Re: Structural Evaluation of 100' Monopine Tower
Waukesha Airport II, WI
Site Number 784719
LEI Project No: 31170053.000

As requested, I have evaluated the letter, drawings and calculations for their structural content, that were submitted to the City of Waukesha by US Cellular which are dated January 23, 2016.

Figure 1. Splice Configuration at 80 Feet.

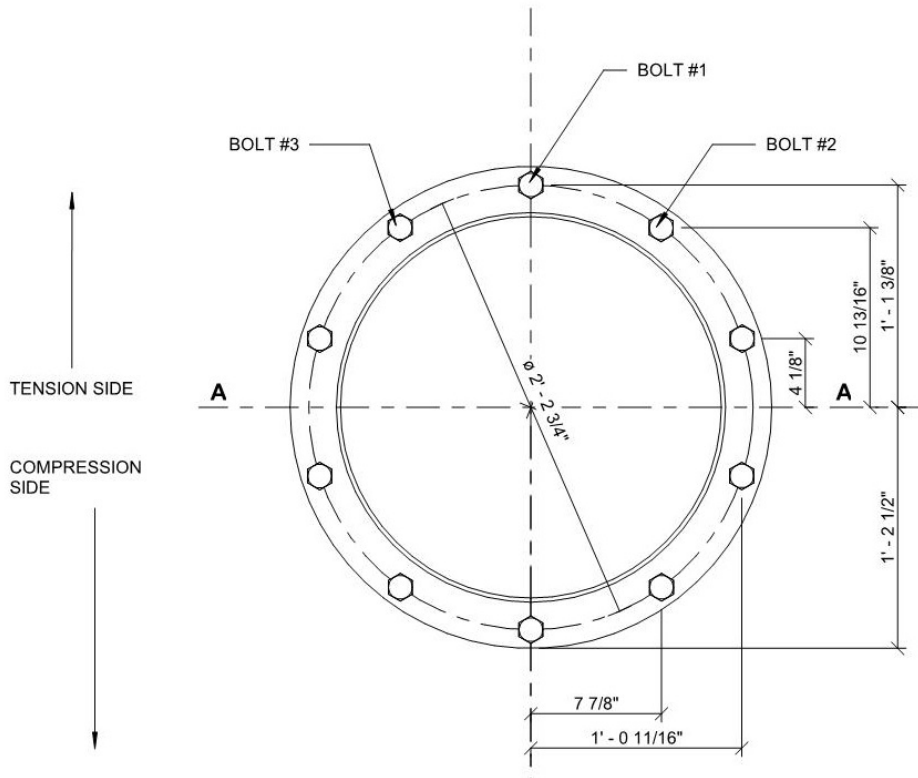
Splice at 80' is an end plate type connection with (10) - 7/8" diameter A325 bolts. See Figure 1. The splice is the point at which failure would first occur under the wind load according to the calculations submitted. Its capacity vs. load is shown as 96.2 % of unity.

The monopole itself is at a much lower unity ratio, and therefore it appears from the calculations submitted that the weak link in the entire structure is the splice at 80'. If the splice is loaded to its failure load the rest of the structure would not be at failure load. There are two critical conditions where the splice may fail. If the pole is bending about the A-A axis as shown in Figure 1, or if the pole is bending about the B-B axis as shown in Figure 2.

Refer to Figure 1. Based on the A-A axis bending direction, bolt #1 would fail first. Once bolt #1 fails, bolts 2 and 3 quickly overload and fail. This effect cascades to all the other bolts in rapid

succession causing the entire splice to fail. This would lead to a separation of the upper pole from the lower pole at 80 feet.

Figure 2. Splice Configuration at 80 Feet.

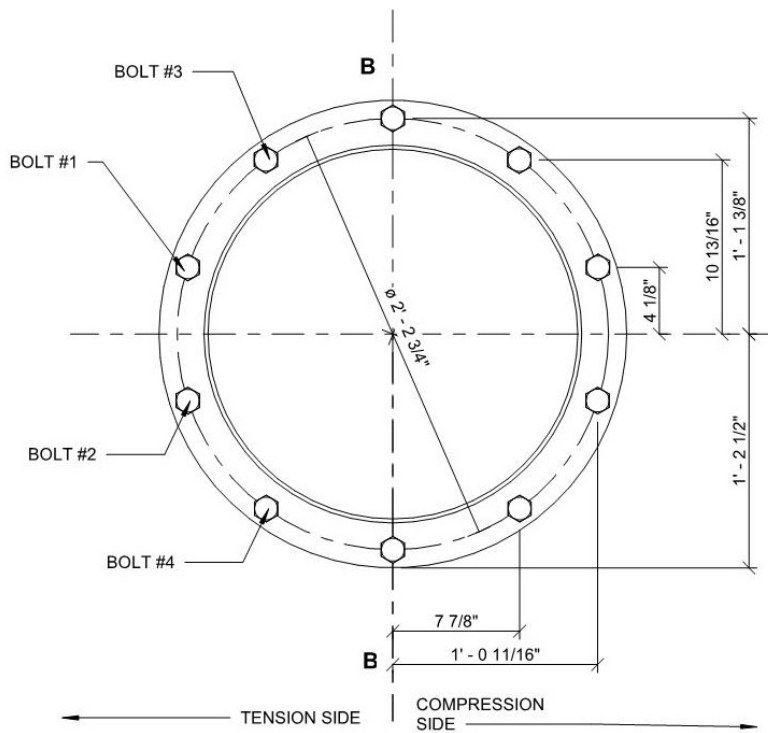
Based on the B-B axis bending direction, bolts 1 and 2 would fail at the same time. Bolts 3 and 4 would instantaneously after that, causing the entire top part of the tower to separate from the lower portion.

Figure 3. Site Plan per C-5

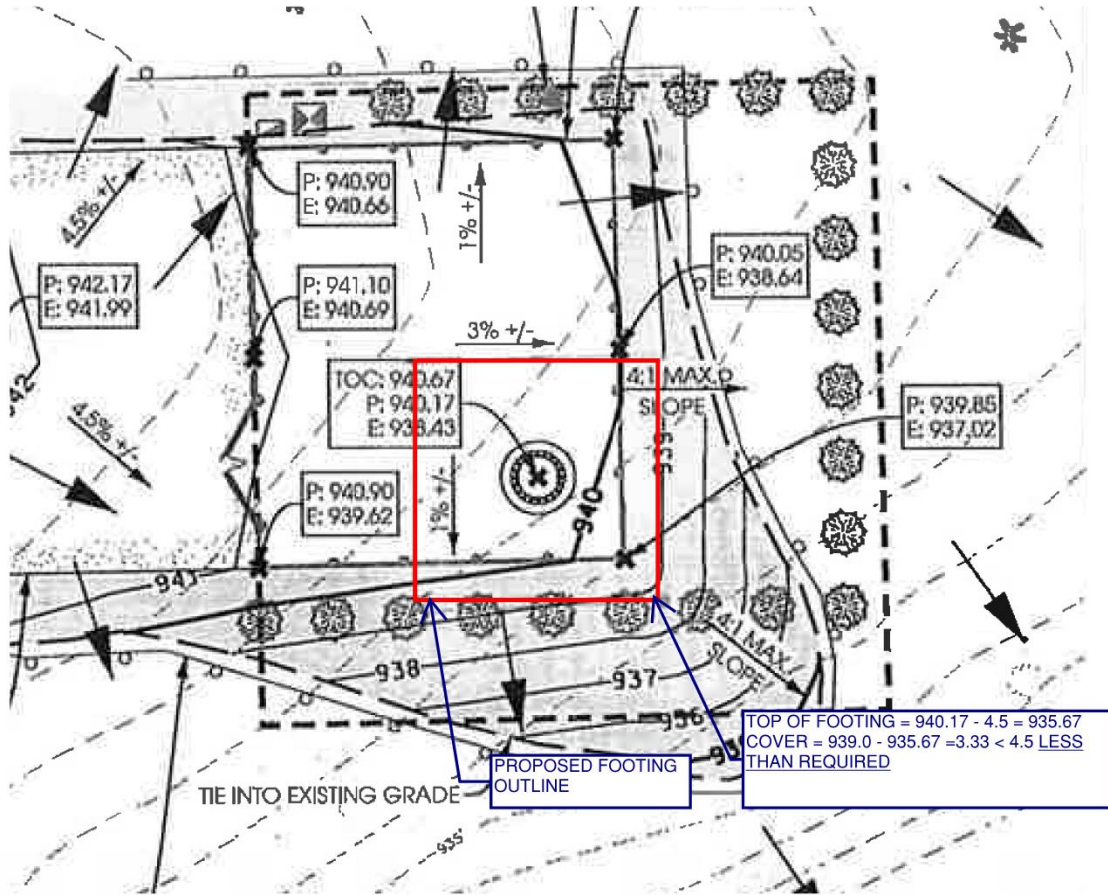
See Figure 3. The foundation for this tower is a 23 foot x 23 foot concrete pad buried 4' - 6" below grade. Referring to figure 3 which is part of the C-5 drawing supplied by US Cellular. The cover indicated by the drawings is not sufficient to satisfy the design in the calculations. There is a note on the C-5 drawing upper right-hand corner that anticipates this happening. Therefore the grading plan would need to be changed to satisfy the calculations given.
